## Product Change Notice (PCN)

**PCN Number:** PCN-0374226R-01

- CPE 1785

#### ❖ Appearance

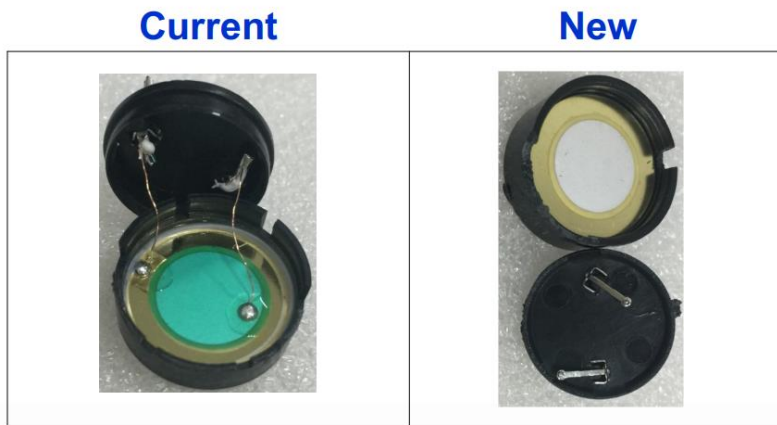
- Case markings Change from NORYL case to PBT
- Bottom notches going from 6 to 2

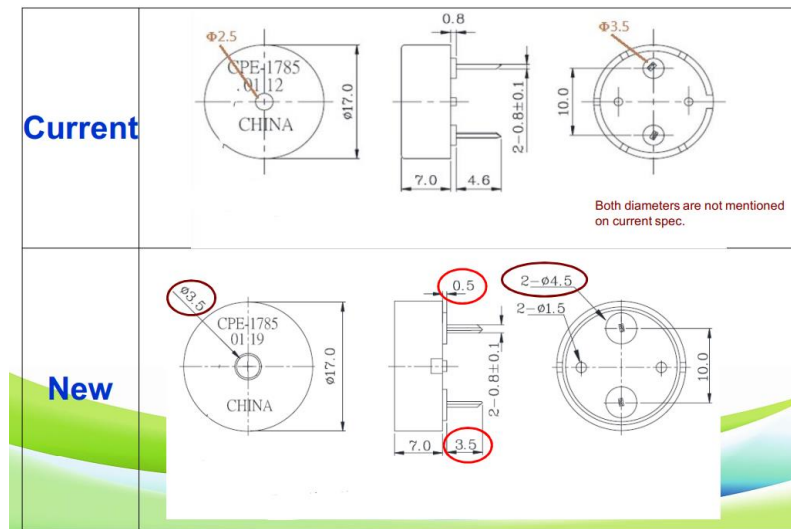
- ❖ **Inside structure**
  - **Change from solder mask on inside to spring contact**

- ❖ **Pin length from 4.6mm to 3.5mm**
